Title - Sujet Palace Grand Theatre Foundation Rep	
Solicitation No. - N° de l'invitation EZ899-152418/A	Amendment No. - N° modif. 012
Client Reference No. - N° de référence du client	Date 2015-07-29
GETS Reference No. - N° de référence de SEAG PW-\$PWY-022-7522	
File No. - N° de dossier PWY-5-38030 (022)	CCC No./N° CCC - FMS No./N° VME
Solicitation Closes - L'invitation prend fin at - à 02:00 PM on - le 2015-08-04	
F.O.B. - F.A.B. Plant-Usine: <input type="checkbox"/> Destination: <input checked="" type="checkbox"/> Other-Autre: <input type="checkbox"/>	
Address Enquiries to: - Adresser toutes questions à: Arthur (PWY), Carolyn	Buyer Id - Id de l'acheteur pwy022
Telephone No. - N° de téléphone (604) 775-6667 ()	FAX No. - N° de FAX (604) 775-6633
Destination - of Goods, Services, and Construction: Destination - des biens, services et construction: Parks Canada - Palace Grand Theatre - Dawson City, YT

Amendment 12

Palace Grand Theatre Foundation Replacement
Palace Grand Theatre, Dawson City, YT

ADDENDUM No. 7
July 28, 2015

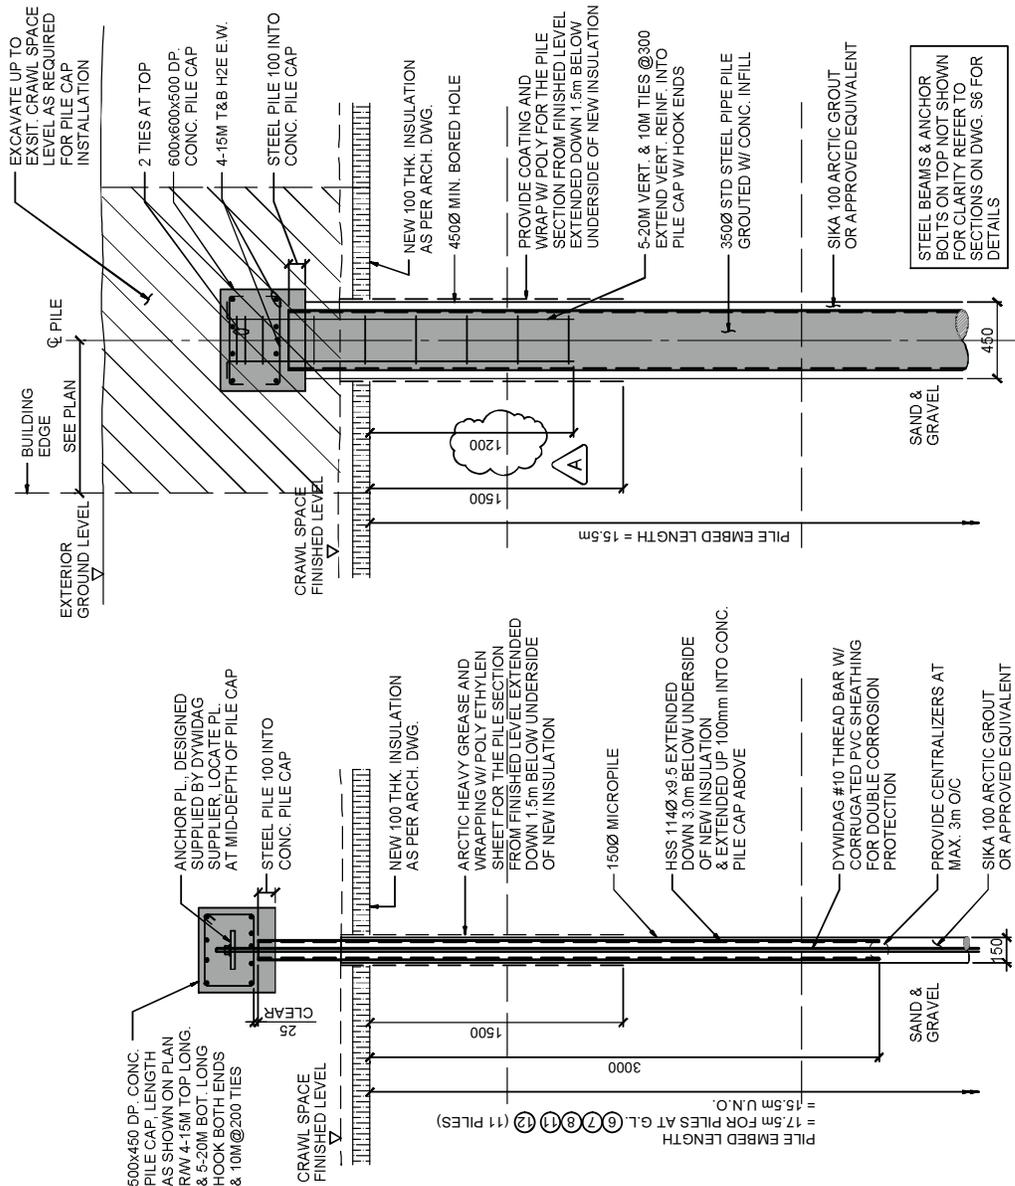
- .1 **Clarify** the rebar cage depth for the steel pipe pile as per attached addendum sheet AD-S01 Revision A.
